December 8, 2023  
223384

**Re: 1050-1058 PANDORA AVENUE HERITAGE BUILDING  
TAX INCENTIVE PROGRAM THIRD-PARTY STRUCTURAL ASSESSMENT**

This report focuses on the assessment of the proposed seismic design strategy of the heritage structure and commentary on the construction costs associated with seismic restraint of the retained heritage components.

Figure 10 – Original Heritage Structure Layout

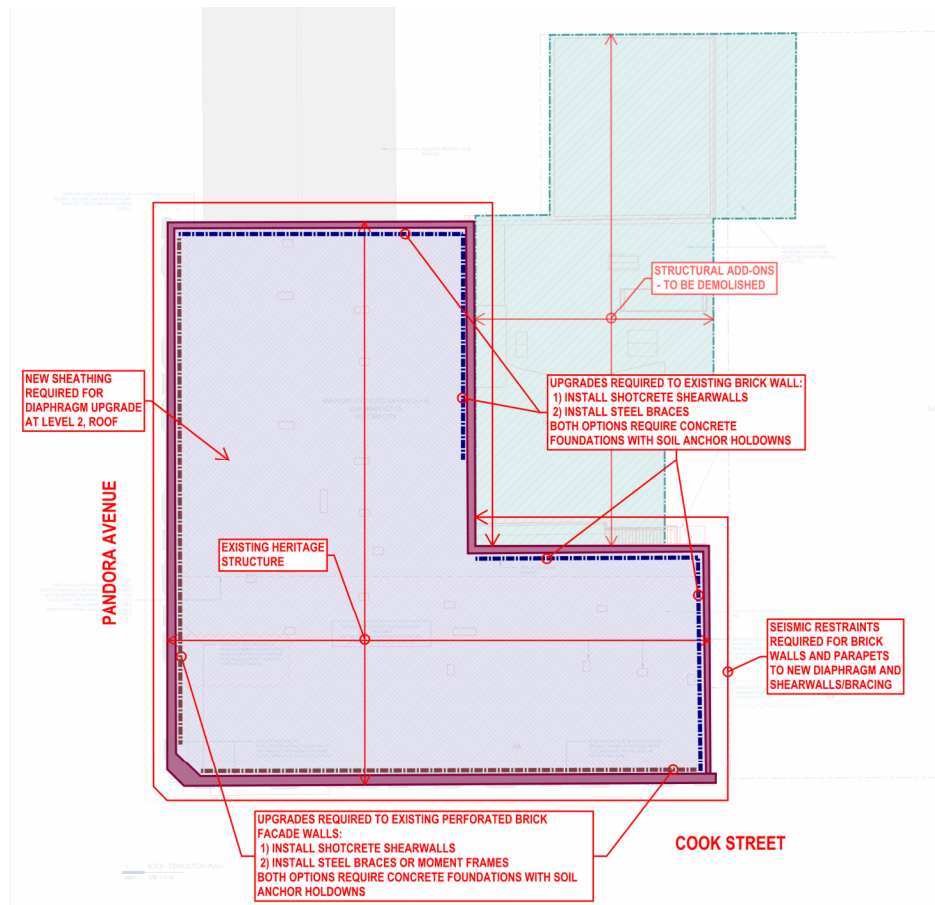
It is possible for the existing heritage structure to be retained but to do so would require extensive retrofit. Given the seismic design requirements mentioned previously and the inadequacy of the existing structure, new seismic resisting elements are required to support the structure; possible options include concrete shotcrete shearwalls and steel braces or moment frames. All of these lateral force resisting systems will require extensive new concrete foundations, likely complete with soil anchors drilled to provide overturning resistance. The existing diaphragms require upgrade, likely with a combination of new plywood sheathing and steel straps or alternatively a reinforced concrete topping, to drag seismic loading back to the new shearwalls/braces. Additional to this, back-up framing would be required to support the exterior walls to tie the existing framing back to the new diaphragms.

While it is technically feasible to retain these elements, they require extensive intervention to the existing structure including spatial allowances required to install the lateral bracing, further reducing occupiable space. These upgrades require significant cost, typically far beyond the revenue that can be generated by the upgrade space over the extended life of the structure. Additionally, the amount of residential area is limited to the pre-existing areas at Level 2, thus not allowing for full utilization of the site for housing.

Figure 11 – Second Storey Heritage Retention Plan (As Proposed by Developer)

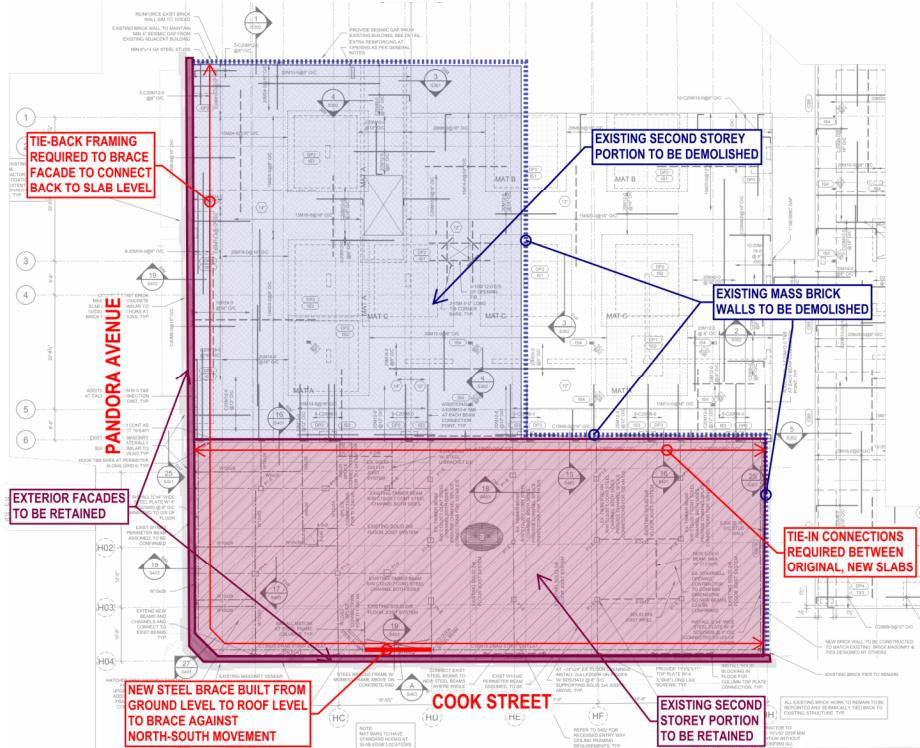
The brick façade does not have sufficient out-of-plane capacity to resist horizontal lateral movement in a seismic event (i.e. pulling away from the main building) and will require back-up framing. The façades are proposed to be retrofitted with tie-backs to the second storey and roof framing with supplemental steel posts and beams as well as connections. Additional framing is also required to support the parapet at the roof level. Additionally, there is very little in-plane stiffness or strength for the brick to act as a shearwall along the lengths of the wall; tie-in to the slab diaphragms is essential for bracing against out-of-plane and in-plane loading.

Roughly half of the existing second storey slab framing will be retained as part of the new proposed development. While the existing 2x8 slab and dropped timber framing (with new steel beam reinforcing) is adequate to support gravity loading, there is insufficient diaphragm capacity to distribute the seismic loads from both the slab and façade weights to new vertical steel braces or

concrete shearwalls; new supplemental plywood sheathing will be nailed to the top of the existing slab.

The existing slab portion to be retained will be connected to a new concrete slab to the west. Additionally, a steel brace frame is being constructed to brace the east side of the slab portion just behind the brick façade along Cook Street to brace both the second storey and new roof framing against north-south seismic loading. All of the seismic loading from the façade and remaining second storey framing will be resisted by the new steel frame along Cook Street as well as the concrete shearwalls to the west supporting the new second storey concrete slab.
